PLANNED UNIT DEVELOPMENT,
PLANNING APPROVAL, SUBDIVISION &
SIDEWALK WAIVER REQUEST STAFF REPORT **Date: July 22, 2010**

NAME Gulf Coast Asphalt Company Subdivision Unit 2

LOCATION 835 Cochrane Causeway (West side of Cochrane Causeway, 1± mile North of Bankhead Tunnel)

CONTEMPLATED USE *Planned Unit Development* approval to allow multiple buildings on a single building site, *Planning Approval* to allow a bulk petroleum facility in an I-2 Heavy Industry District, *Subdivision* approval to create one legal lot and *Sidewalk Waiver* approval to waive construction of sidewalks along Cochrane Causeway.

SITE PLAN

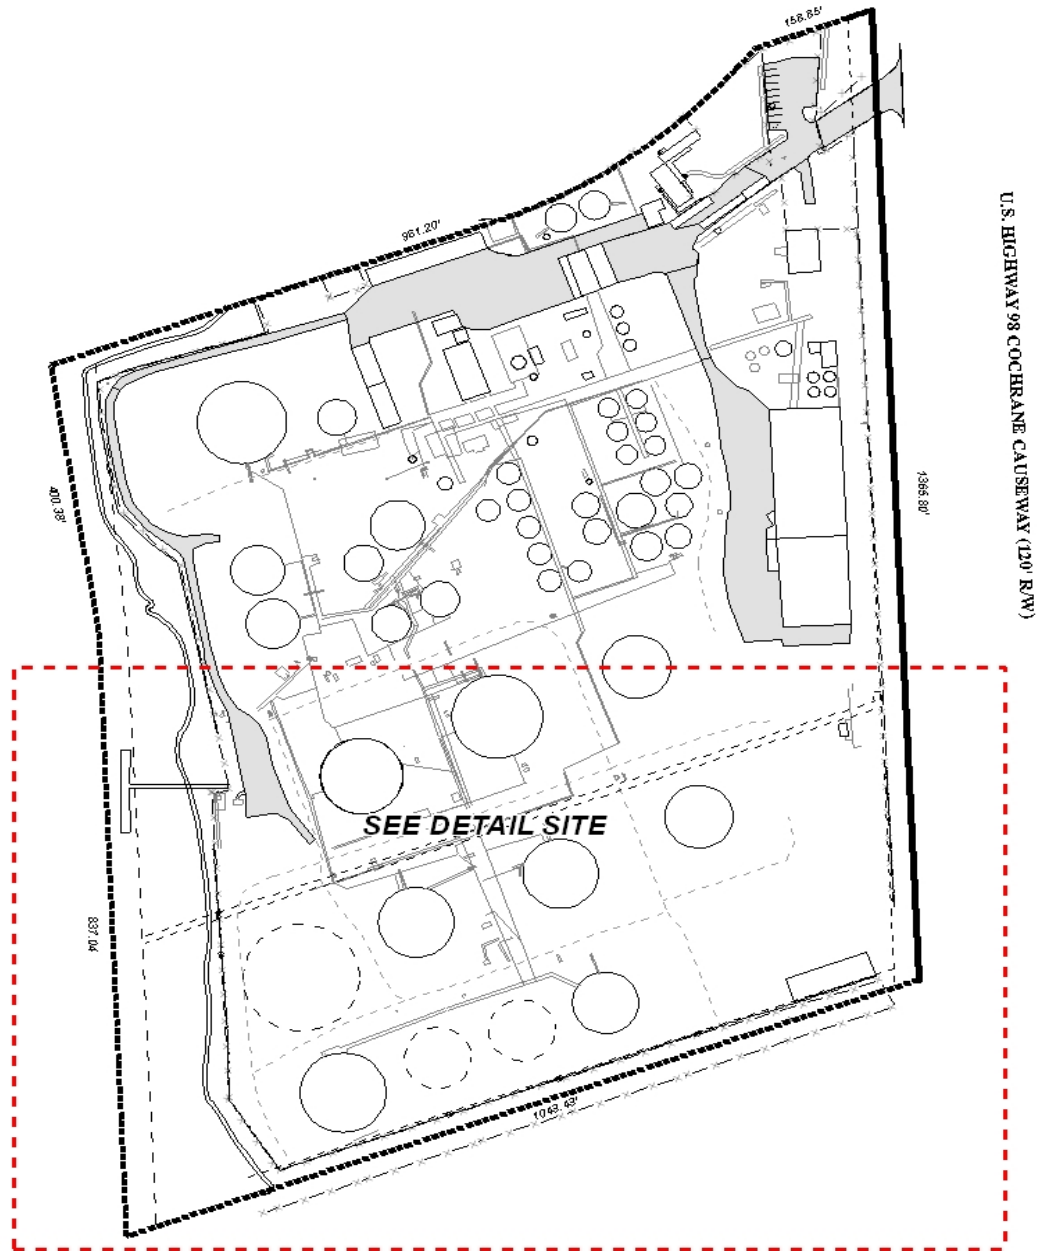
Dumpster locations for the site are not depicted on the site plan to comply with Section 64-4.D.9 of the Zoning Ordinance; therefore, the applicant should make a provision for dumpster locations and place a note on the site plan stating that dumpsters will be completely screened from view. If dumpsters will not be used, provide a statement indicating such, and how garbage will be removed from the site.

The 25-foot minimum building setback line is not depicted on the plat along Cochrane Causeway within the proposed building site; therefore, the preliminary plat should be revised to show the 25-foot setback line along Cochrane Causeway within the proposed building site.

- 1) illustration of site circulation and access for the Southern portion of the site;
- 2) illustration of what type surface material exists on the roadway where the asphalt pavement ends; and
- 3) regarding fire hydrants- how many, location and will any new hydrants be added due to the size of the new tanks.

- 1) illustration of site circulation and access for the Southern portion of the site;
- 2) illustration of what type surface material exists on the roadway where the asphalt pavement ends; and

- 3) regarding fire hydrants- how many, location and will any new hydrants be added due to the size of the new tanks.
- 4) compliance with Urban Forestry comments: Property to be developed in compliance with state and local laws that pertain to tree preservation and protection on both city and private properties (State Act 61-929 and City Code Chapters 57 and 64) Full compliance with frontage tree requirements of the Zoning Ordinance to be coordinated with Urban Forestry;

- 6) depiction of dumpster locations on the site plans to comply with Section 64-4.D.9 of the Zoning Ordinance or placement of a note on the site plans stating that dumpsters will be completely screened from view or placement of a note stating how garbage will be removed;

- 7) placement of a note on the site plan stating that approval of all applicable Federal, state and local agencies for endangered, threatened or otherwise protected species is required prior to the issuance of any permits or land disturbance activities;
